ADMINISTRATIVE AMENDMENT

PROJECT #1000188

WEST BLUFF
RETAIL CENTER

OVERALL SITE PLAN
FOR SUBDIVISION

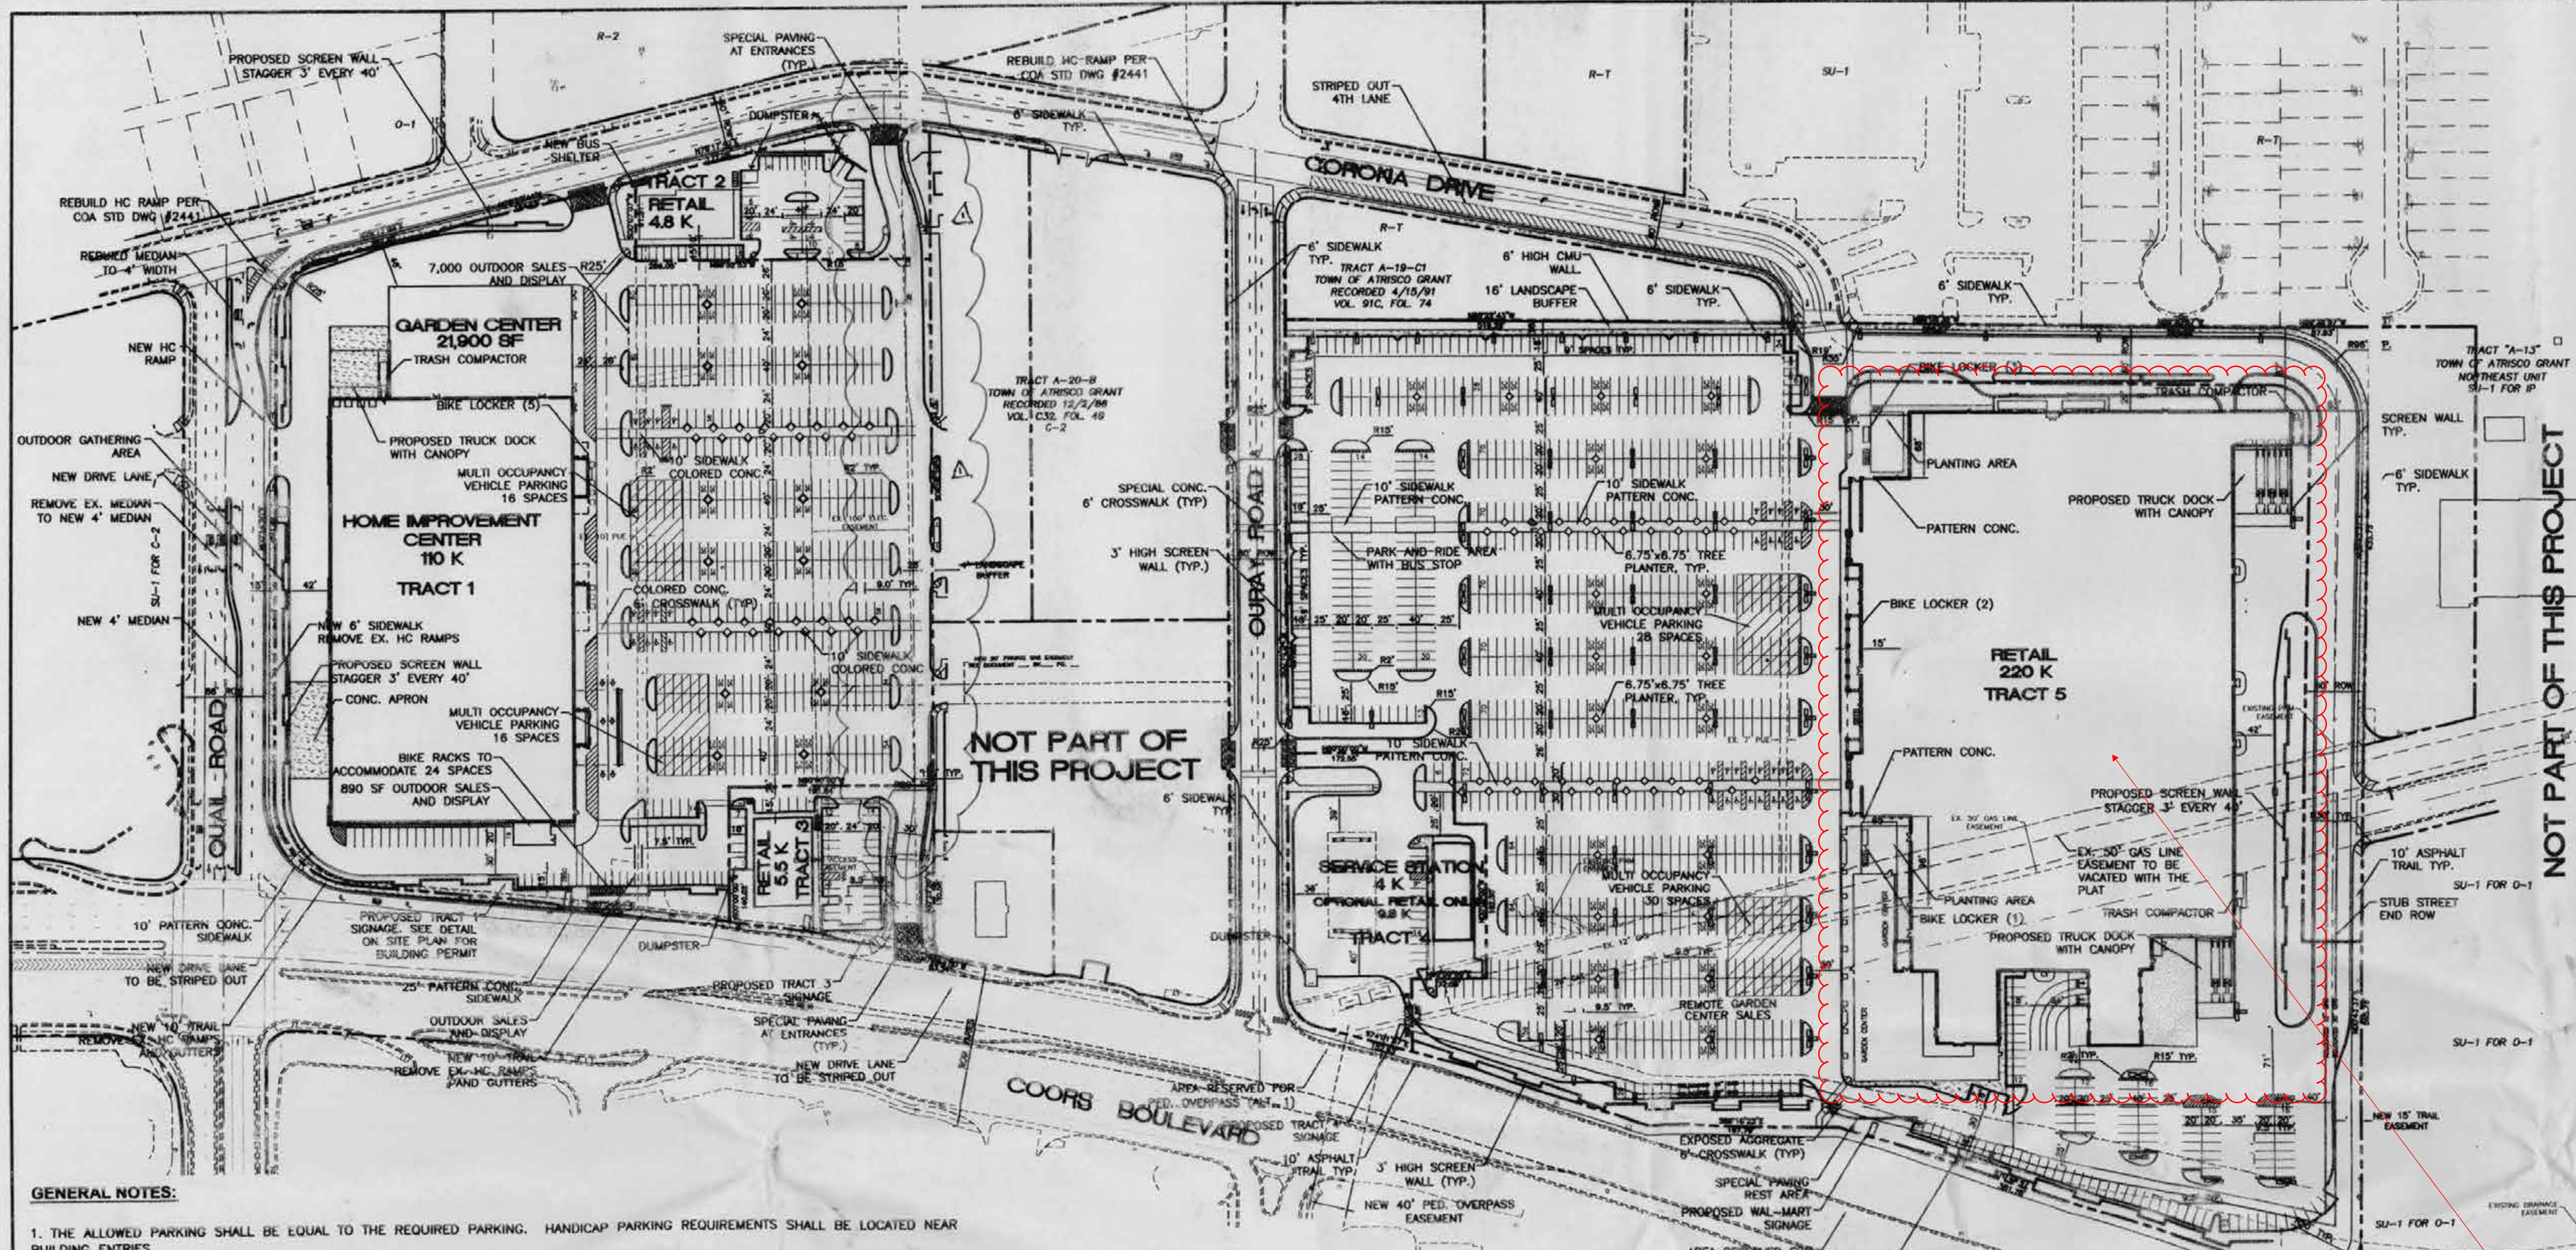
A Added Access to Southern Parcel
